Well Name	Well Number	US Well Number	Lease Number	Case Number	Operator
JAMES RANCH	114H	3001555828	NMNM02952A	NMNM70965X	XTO PERMIAN
JAMES RANCH	804H	3001555829	NMNM02952A	NMNM70965X	XTO PERMIAN

Notice of Intent

Type of Action: APD Change

Form 3160-5
(June 2019)UNITED STATES
DEPARTMENT OF THE INTERIOR
BUREAU OF LAND MANAGEMENTFORM APPROVED
OMB No. 1004-0137
Expires: October 31, 2021**SUNDRY NOTICES AND REPORTS ON WELLS**
Do not use this form for proposals to drill or to re-enter an abandoned well. Use Form 3160-3 (APD) for such proposals.

Previous Design: 4-String Design – Engineered Weak Point**[Figure F] 4 String – 2nd Intermediate casing engineered weak point**

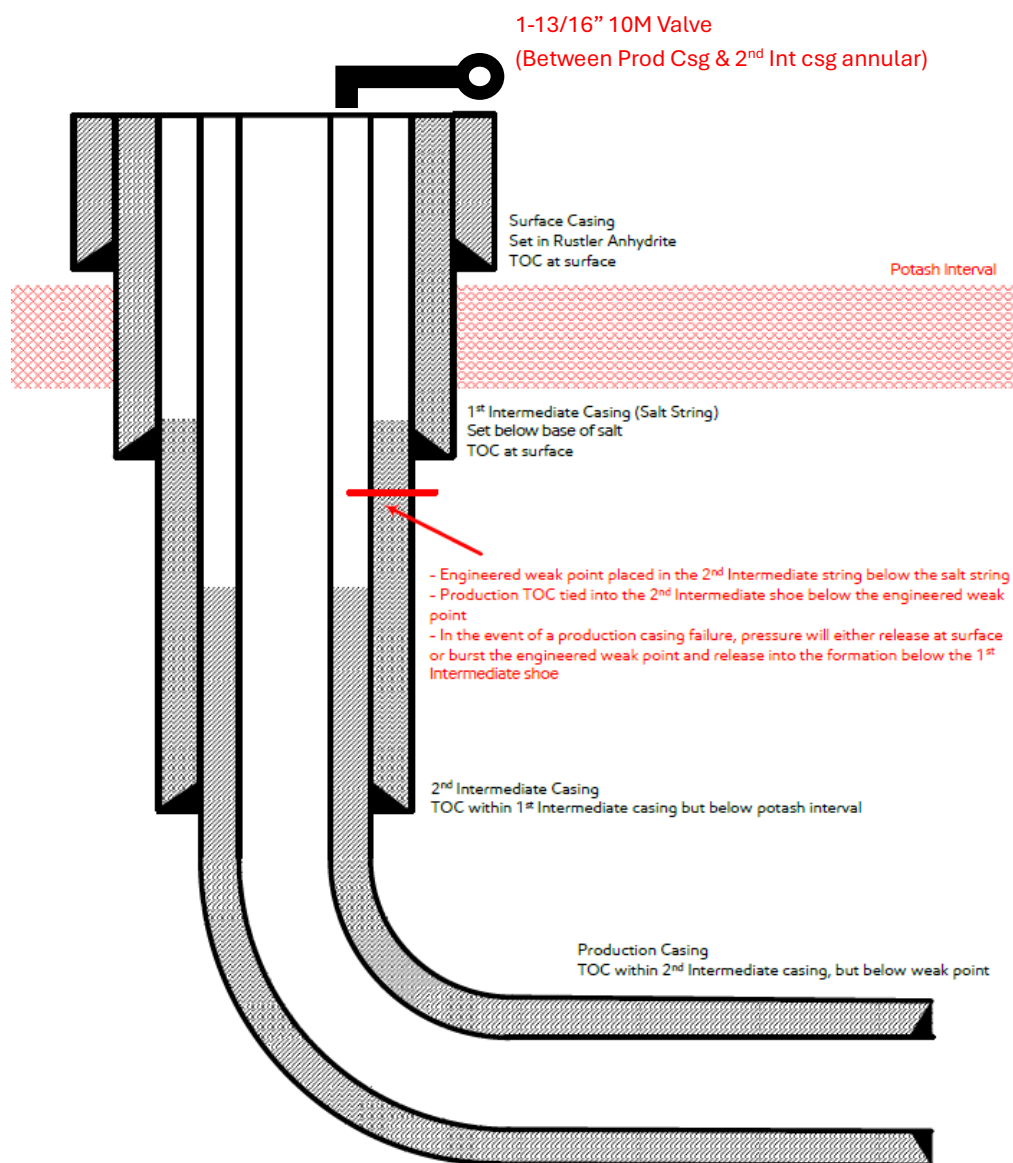
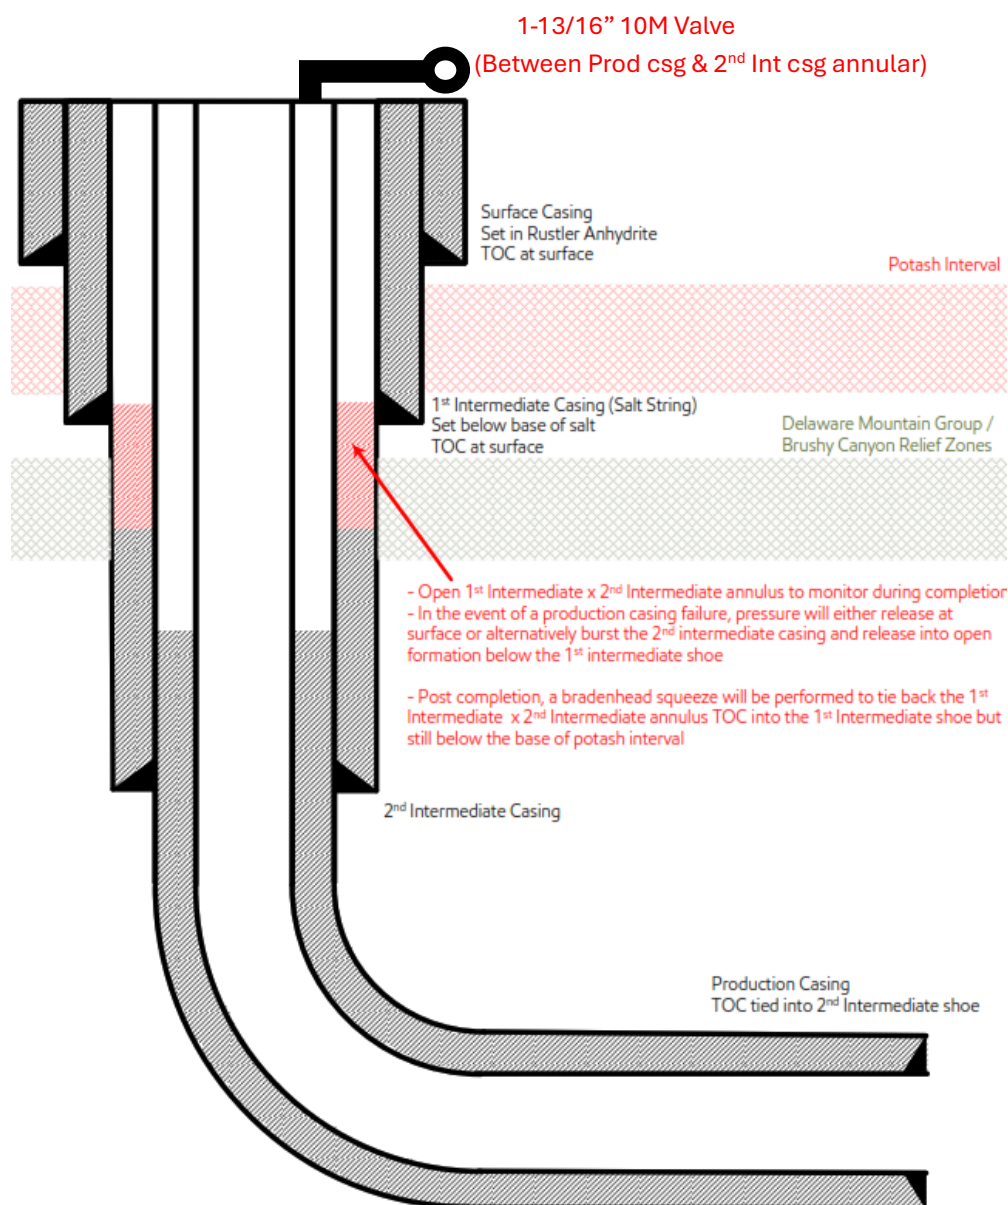
1. Casing design to be changed from the "4-String Design – Engineered Weak Point" (FIGURE F) to the "4-String Design – Open 1st INT x 2nd INT Annulus" (FIGURE D). An open annulus will be utilized and monitored during completions operations.

Post completion, bradenhead squeeze will be performed to tie back the 1st intermediate x 2nd intermediate annulus. TOC will be placed into the 1st intermediate shoe but still below the base of Potash interval.

2. No changes to the cementing, casing or mud circulating system designs will be required for the requested change.

New Proposed Design: 4 – String Design – Open 1st Int X 2nd Int Annulus (ICP 2 below relief zone)

[Figure D] 4 String – Uncemented annulus between 1st and 2nd intermediate casing strings

- 1) Alignment with KPLA requirements per schematic above, leaving open annulus open for pressure monitoring during frac and utilizing new casing that meets API standards.
- 2) Contingency plans in place to divert fluids away from salt interval in event of production casing failure.
- 3) Intermediate 2 bradenhead squeeze to be completed within 180 days to tieback TOC to salt string at least 500ft but with top below Marker Bed 126.
- 4) Production cement to be tied back no less than 500ft inside previous casing shoe.
